COUNTRY CLUB DR. CULVERT REPLACEMENT

**PROJECT NO. 2021-043
BID NO. 2561**

ADDENDUM 3

November 15, 2022

COUNTRY CLUB DR.
CULVERT REPLACEMENT
CULVERT DESIGN DETAILS
PROJECT # : 2021-043

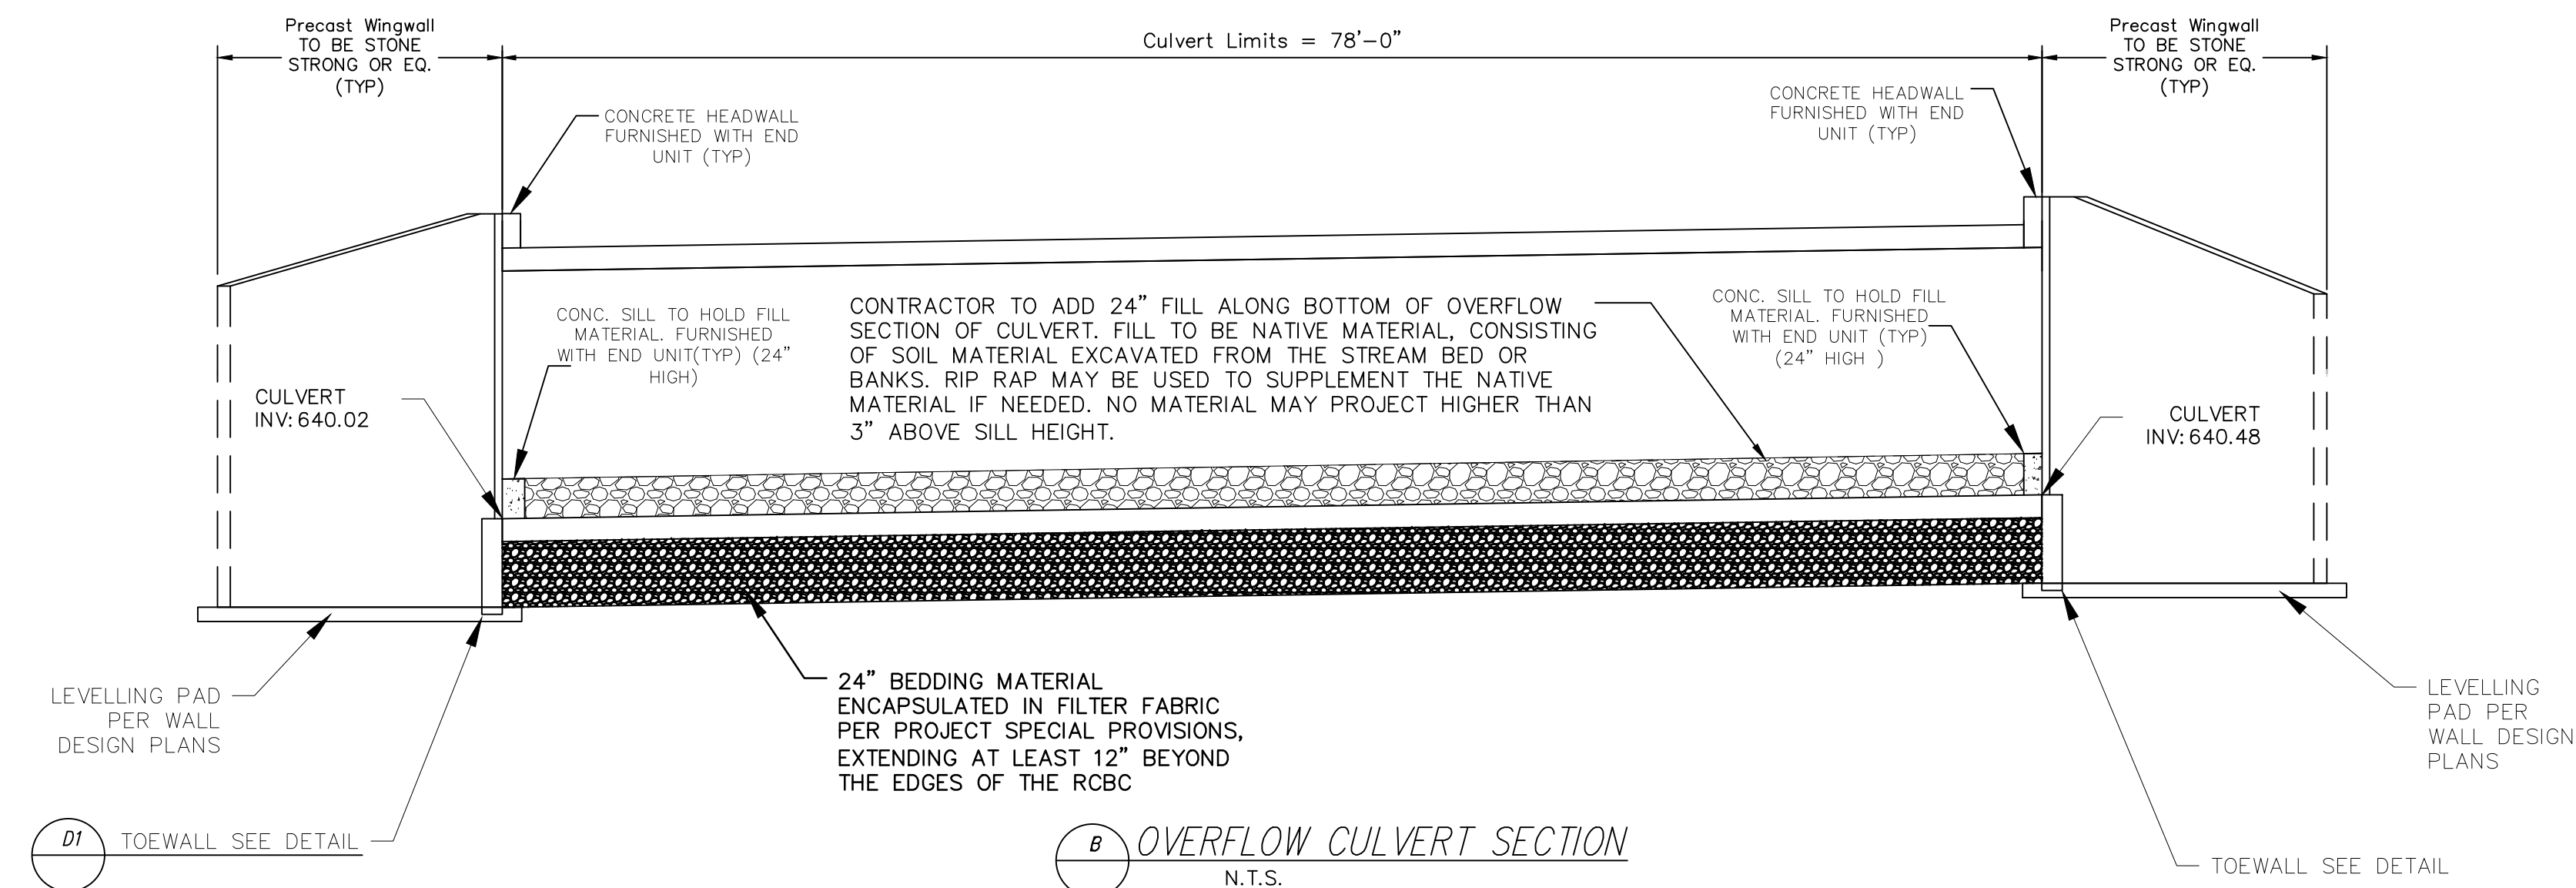
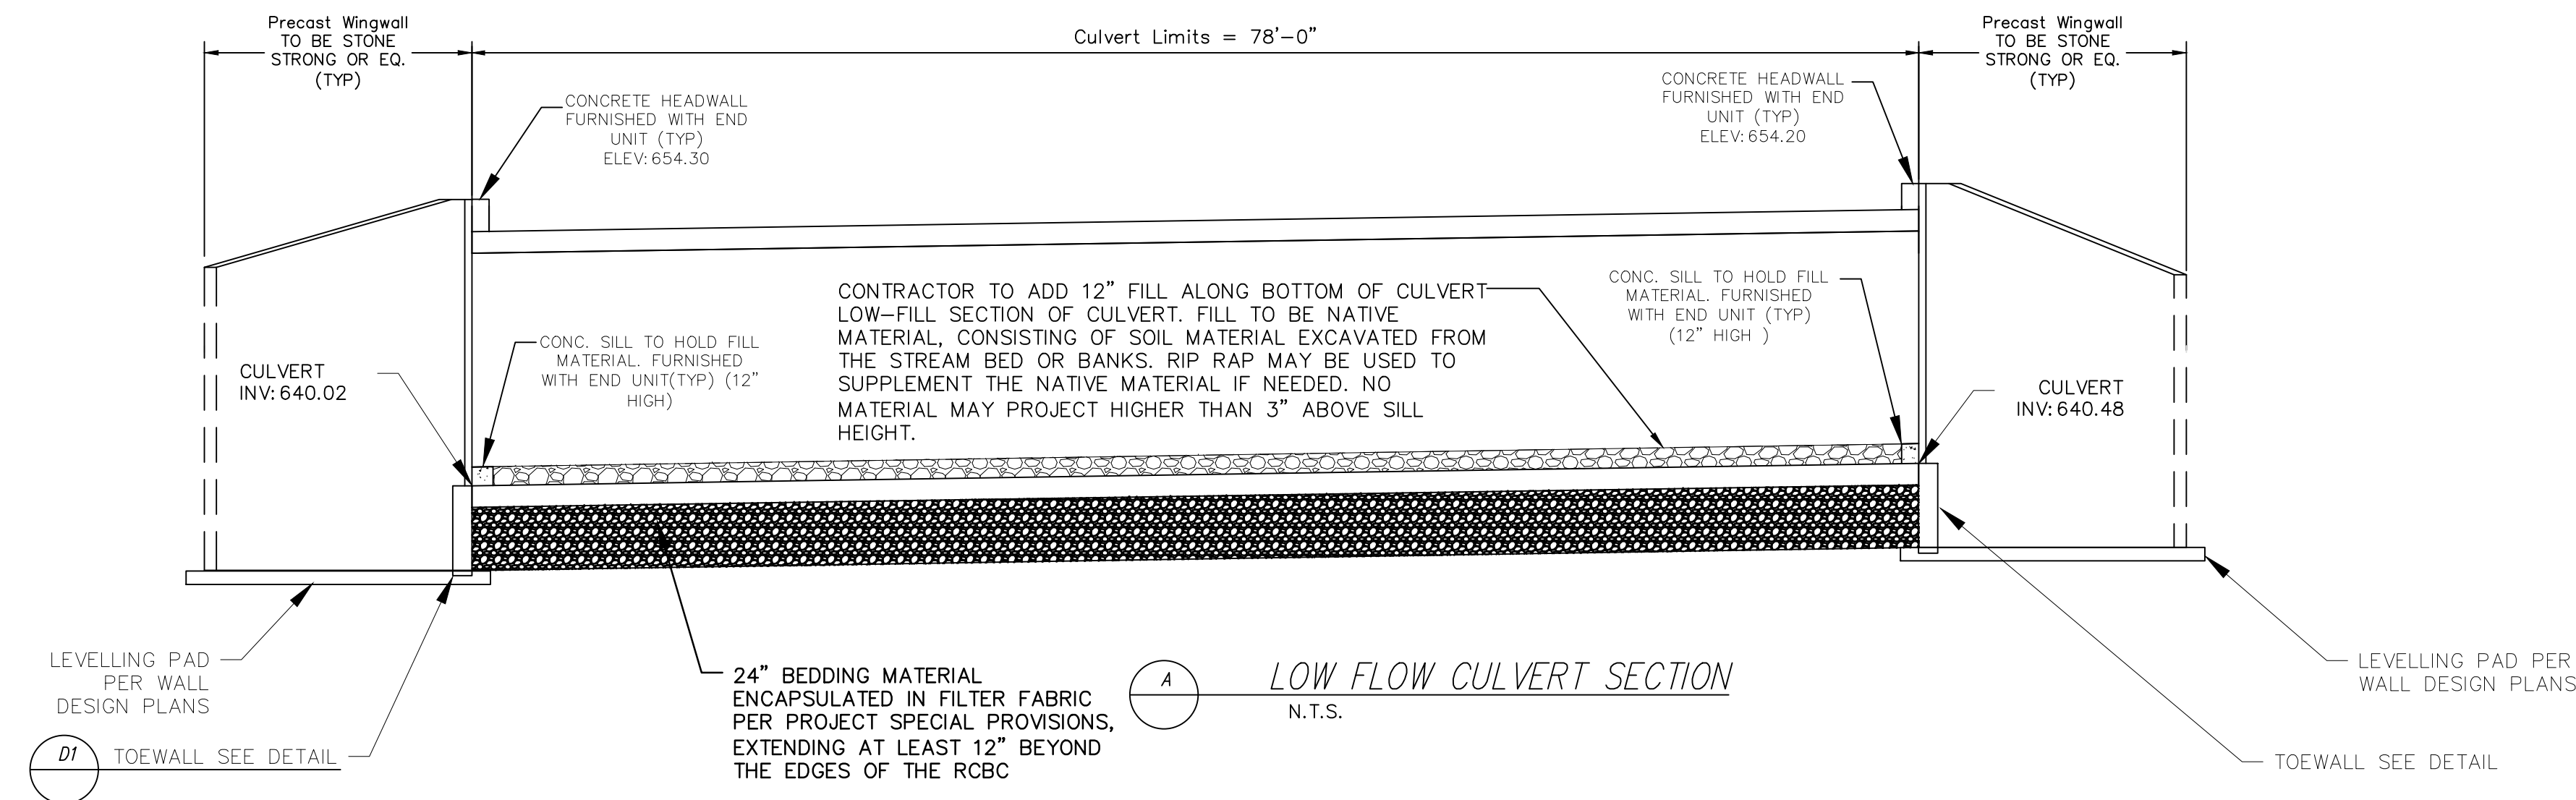
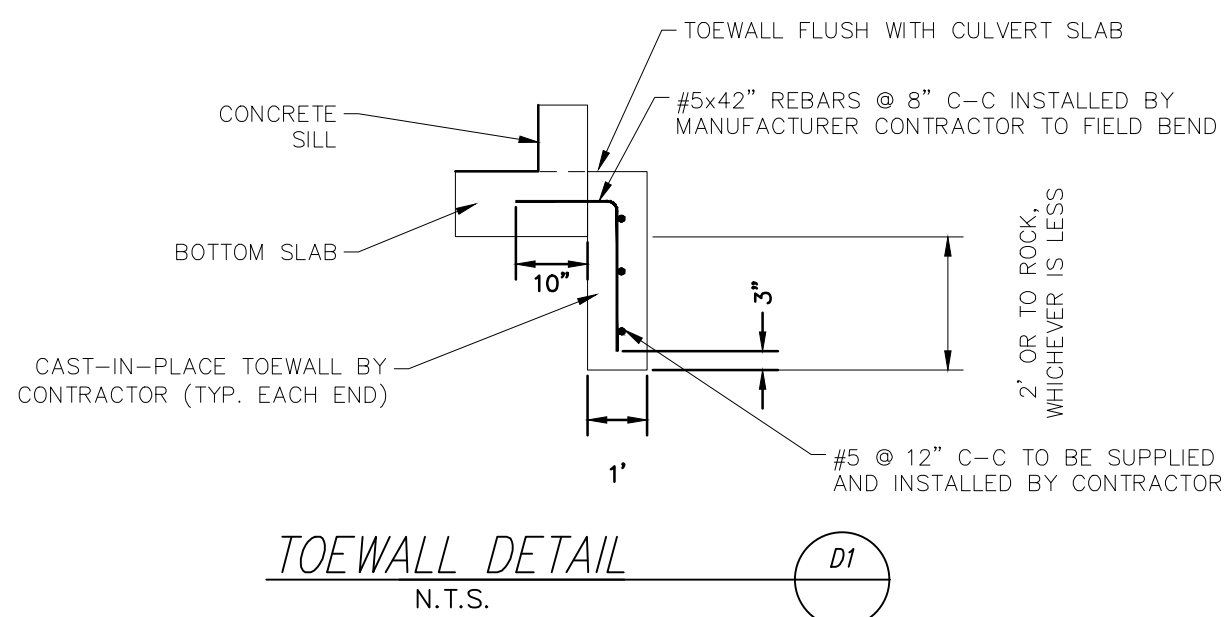
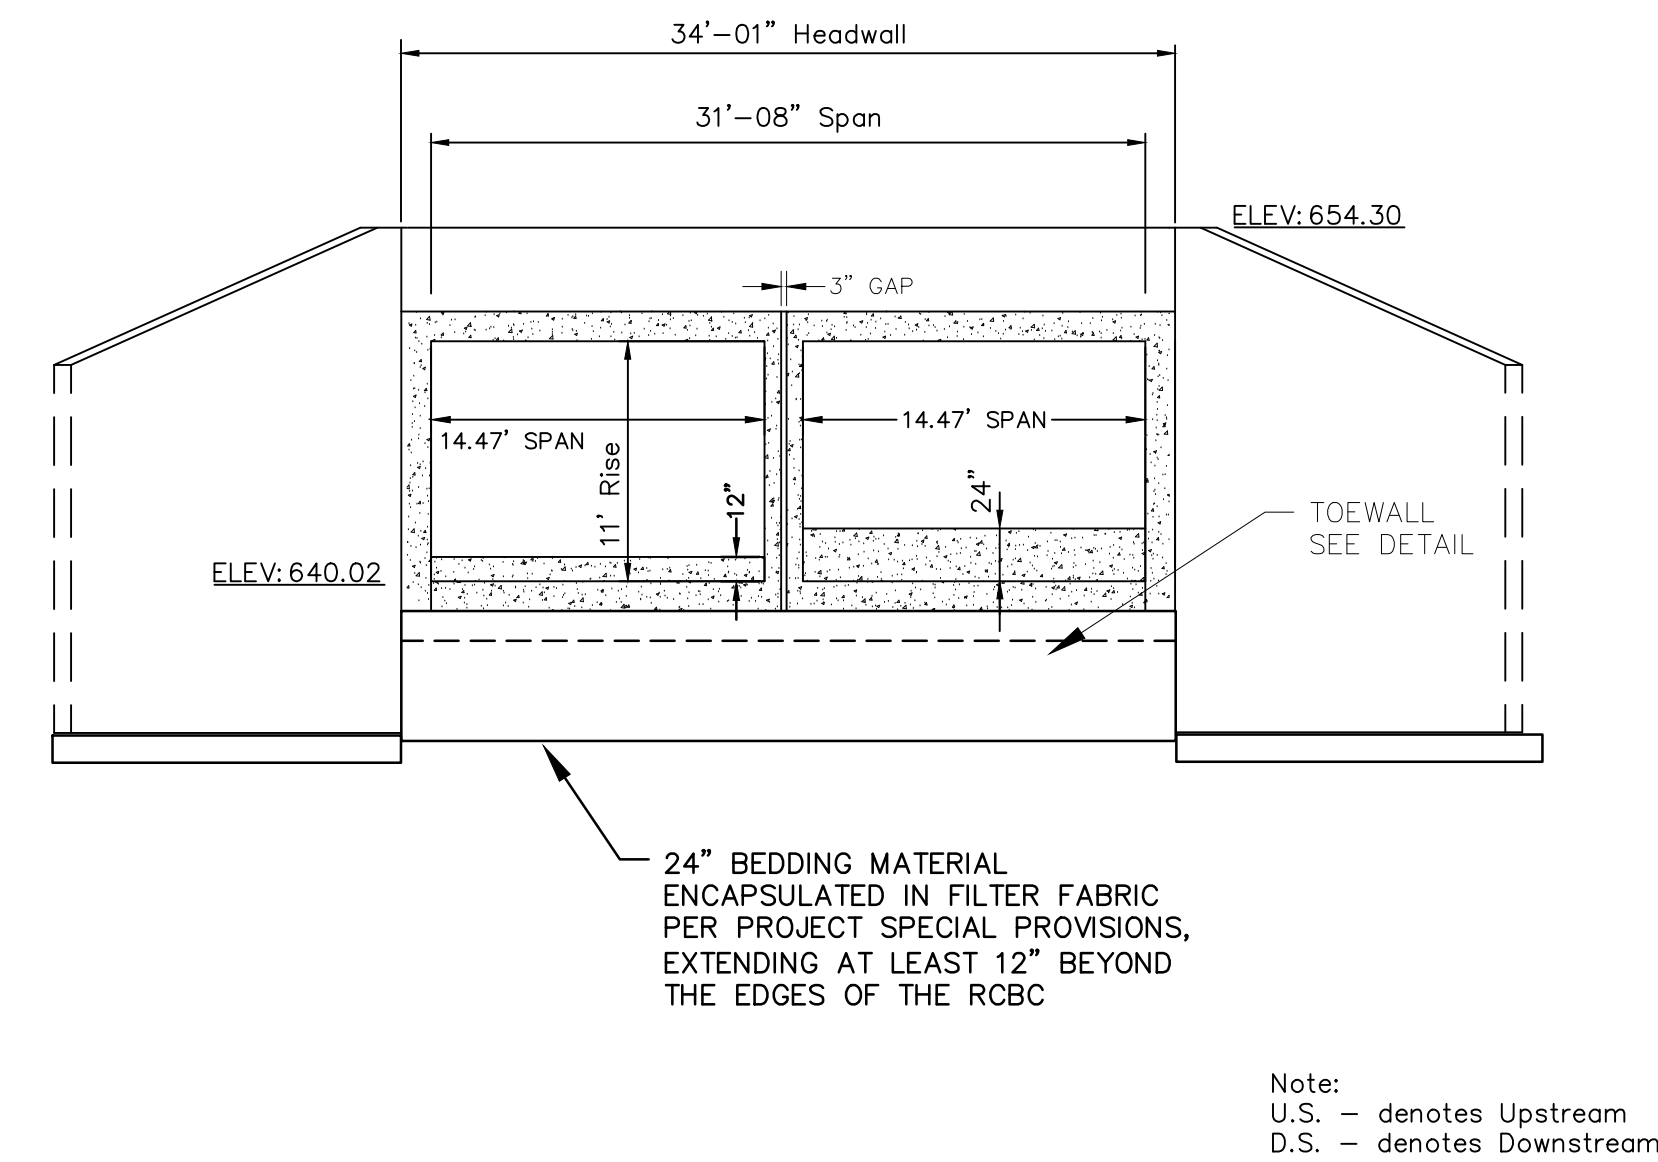
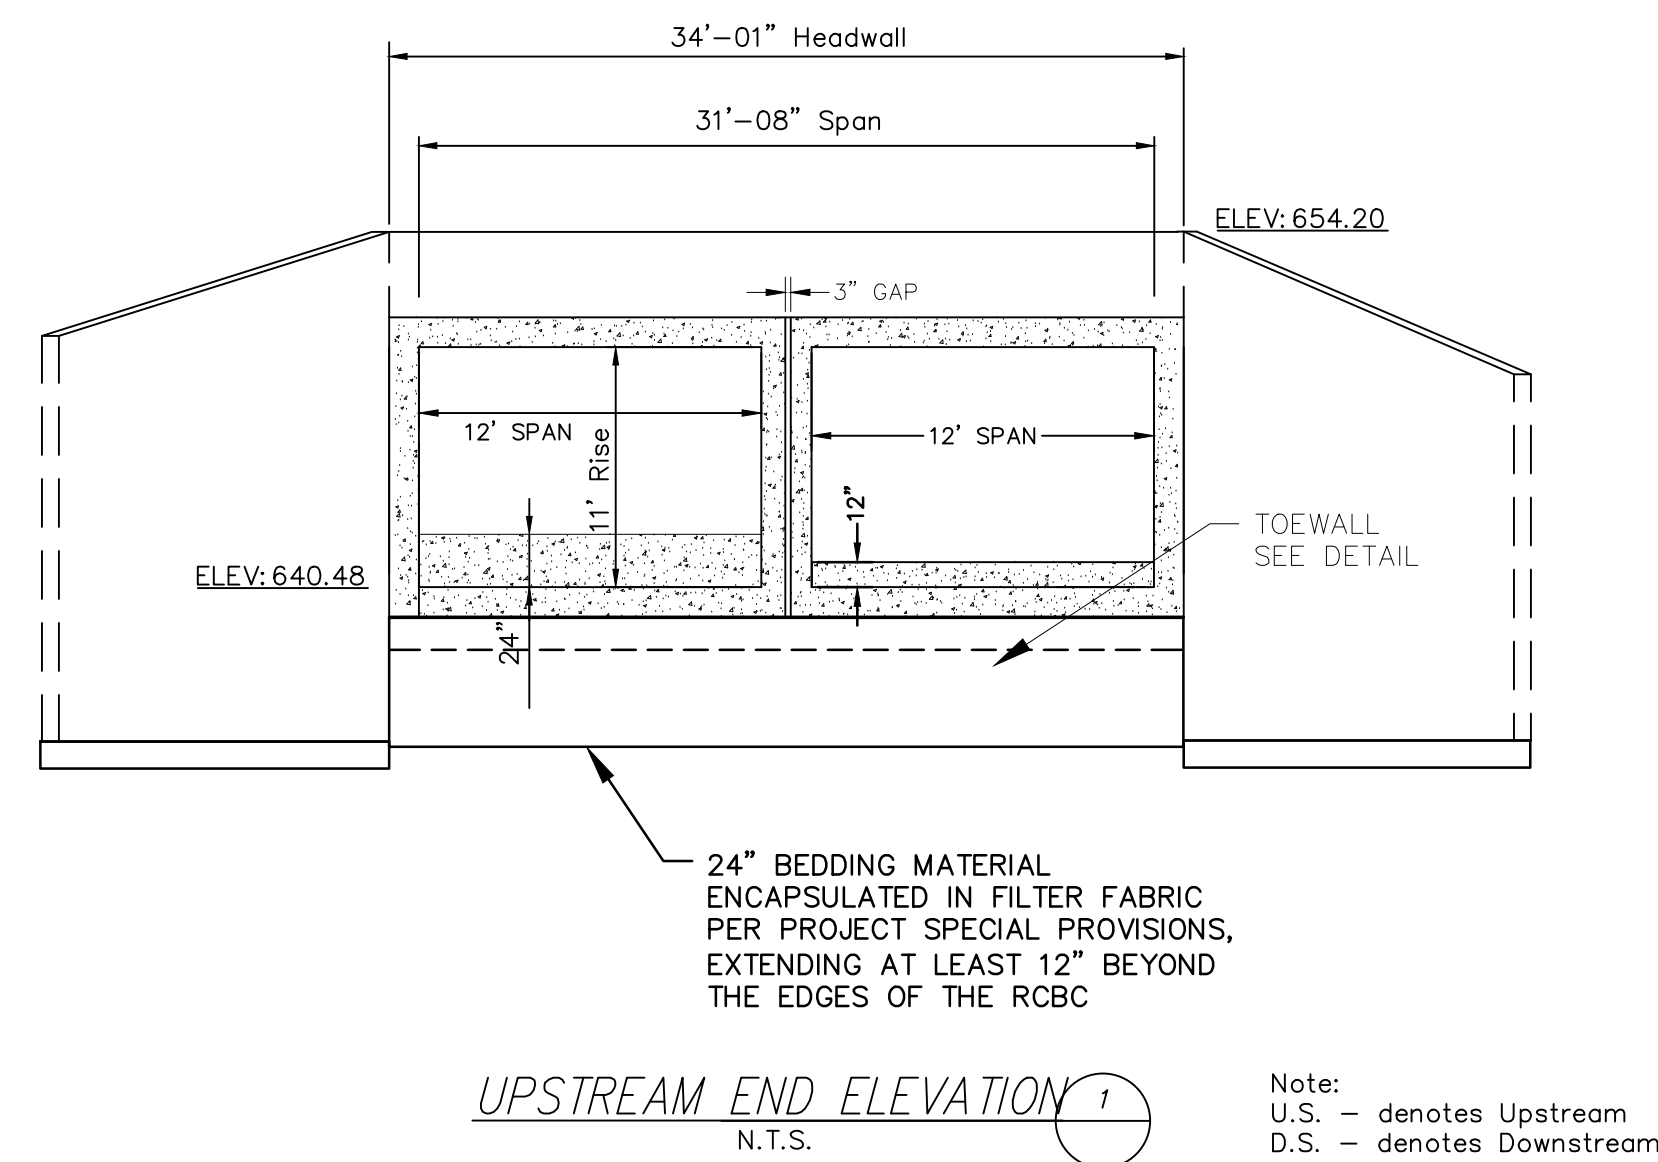
- Replace Special Provision *SP-07 Precast Reinforced Concrete Culvert* in Addendum 2 and Exhibit C of the project bid documents with the following SP. This SP-07 supersedes any previous version. This updates the bedding description in the Installation section to match Figure 2.1.

- Replace sheet 21 of the plans with the following sheet, which updates the culvert bedding to match *SP-07 Precast Reinforced Concrete Culvert*, and updates the wingwalls description.

Bedding for precast culvert shall meet the requirements of Section 410 and 414 of the NCDOT Standard Specifications. Excavate **24 inches** below the bottom of barrel and footings and backfill with Class VI select material in accordance with Section 1016 of the NCDOT Standard Specifications or as shown on the plans. Bedding shall extend **12 inches** outside of the culvert or footings. In addition, bedding material shall be placed on filter fabric conforming to Type 4 requirements in Section 1056 of the NCDOT Standard Specifications. The filter fabric shall be placed perpendicular to the culvert barrel with the geotextile wrapped up and around the conditioning material to fully encapsulated it. Perpendicular sections of fabric shall be continuous. A minimum lap of 2 feet shall be provided between sections of fabric.
